Technical Bulletin

Bulletin No.: PRO-07-01

Subject: **OBSOLESCENCE 3/8" AND 7/16" I.D. HOSE "SHORT" FITTINGS**

FIG. 1

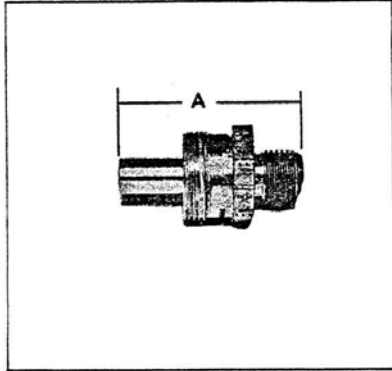
Effective October 1, 1977, this will announce the obsolescence of the "Short" hose fitting (Ref. Fig. 1) and nut (Ref. Fig. 2). The "Short" sleeve will remain available under piece numbers 292615 for 3/8" I.D. hose and 292753 for 7/16" I.D. hose. This will provide availability of the "Short" sleeves for use with the "Short" nuts in the field. The "Old" design "Long" fitting body, nut and sleeve again will be the standard H.V.S.G. hose fitting and will retain their previous piece numbers.

Pc. No.	Size	"A" Dim.	
		"Old" (reinstated effective 10/1/77)	"New" (obsolete effective 10/1/77)
215992	3/8"	2.06"	1.91"
216173	7/16"	1.97"	1.75"

FIG. 2

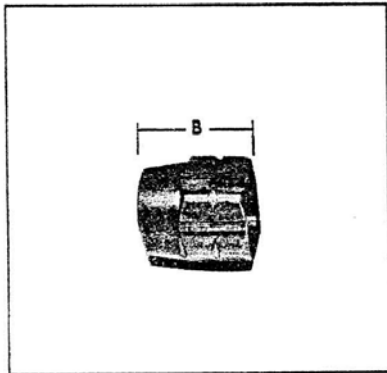
Pc. No.	Size	"B" Dim.	
		"Old" (reinstated effective 10/1/77)	"New" (obsolete effective 10/1/77)
203624	3/8"	1.13"	.94"
212318	7/16"	1.19"	.94"

FIG. 3

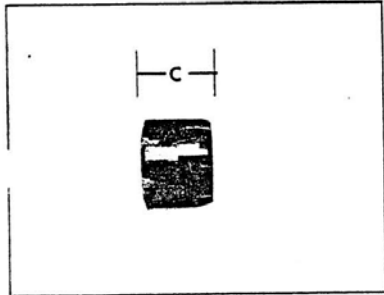
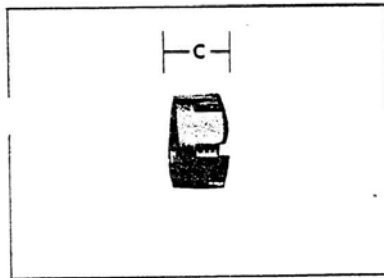
OLD DESIGN
(Slots on both ends)

NEW DESIGN
(Slots on only one end)

Pc. No.	Size	"C" Dim.	
		"Old" (Reinstated effective 10/1/77)	"New"
203610	3/8"	.69"	
204741	7/16"	.69"	
292615*	3/8"		.50"
292753*	7/16"		.50"

* Obsolete - available for service only after 10/1/77.

Combinations of new and old design components can be intermixed except that the old design sleeve cannot be used with the new design nut.

Fig. 4

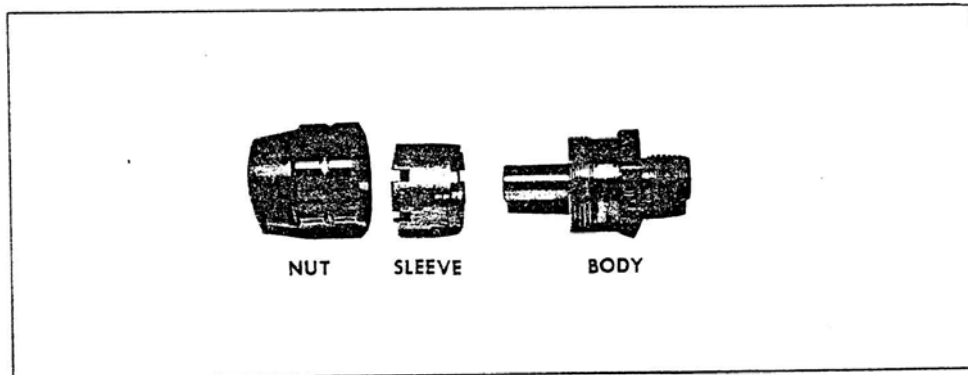
Sleeve must be installed with short slots toward nut.

FIG. 5

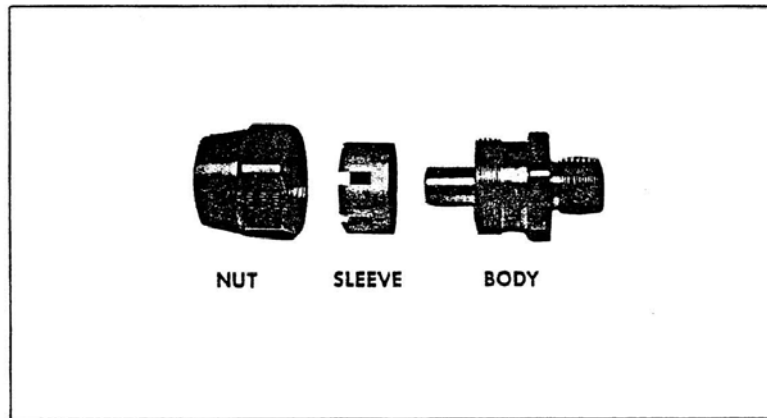
Must be installed with slots toward nut.
